Updated Table 33-11

1. Update table 33-11 item 7 as follows:
2. Update Figure 33-14 accordingly. See attached below.
3. Add the following Editor Note below the above table.

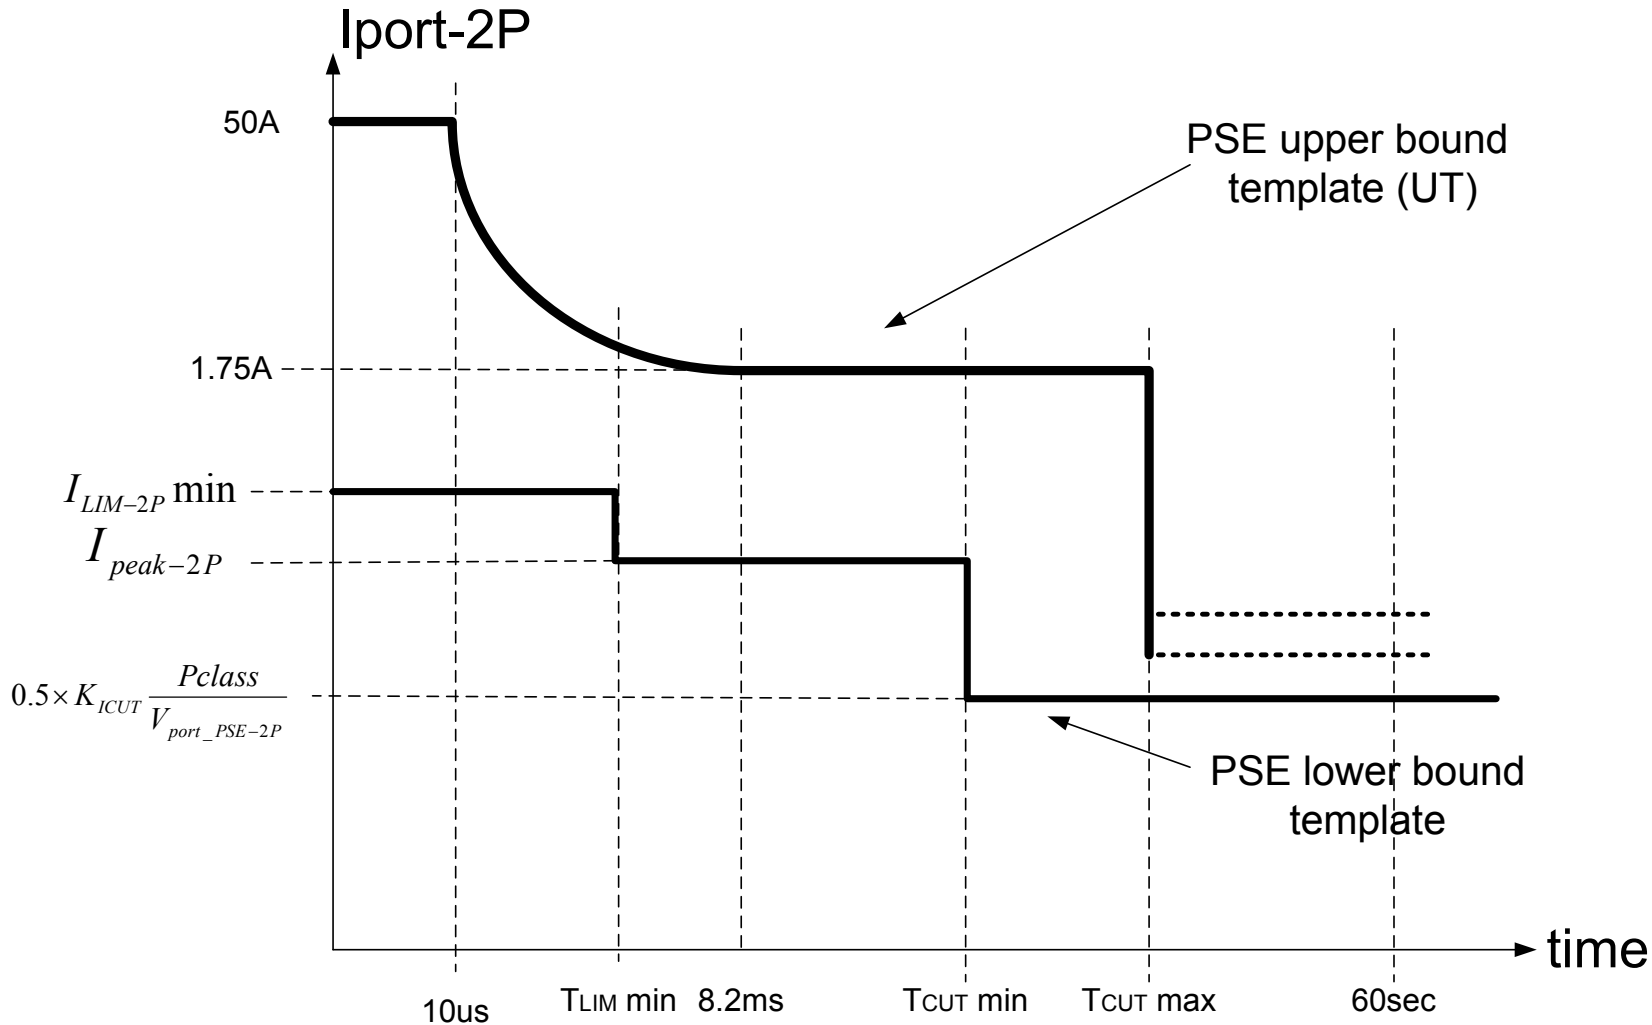
Item	Parameter	Symbol	Unit	Min	Max	PSE Type	Additional Information
7	Overload current per pair set, detection range	I _{CUT-2P}	A	Pclass/Vport_PSE-2P	I _{LIM}	1, 2	Optional LIMIT; See 33.2.7.6, Table 33-7. K_icut3=0.556. K_icut4=0.538.
				Kicut3X		3	
				Pclass/Vport_PSE-2P		4	
				Kicut4 X			
				Pclass/Vport_PSE-2P

Editor Note (to be deleted prior to publication): Icut-2P min values (K_icut3 and K_icut4) are subject to final E2EP2P_Iunb/Runb results after conducting statistical analysis (if it will be required) which will result with lower values. The current values are derived from worst case analysis model. Equation TBD will be supplied for next meeting.

Editor Note (to be deleted prior to publication): To address the following case in future: If PSE is using active or passive pair to pair current balancing circuitry, Kicut3 or Kicut4 may be lower down to 0.5 per equation TBD.

See derivation of the above numbers in Annex A

$I_{cut_min-2P} = I_{cont-2P_unb} = (I_{cont-2P_unb_max}/I_{cont-2P_max}) * 0.5 * P_{class}/V_{port_PSE-2P} = (0.668/0.6) * 0.5 * P_{class}/V_{port_PSE-2P} = 1.113 * 0.5 * P_{class}/V_{port_PSE-2P}$.

$I_{cont-2P_unb} = 0.556 * P_{class}/V_{port_PSE-2P}$ for Type 3 PSE.

In similar way for Type 4: $I_{cont-2P_unb} = (0.931/0.865) * 0.5 * P_{class}/V_{port_PSE-2P} = 1.076 * 0.5 * P_{class}/V_{port_PSE-2P}$.

$I_{cont-2P_unb} = 0.538 * P_{class}/V_{port_PSE-2P}$
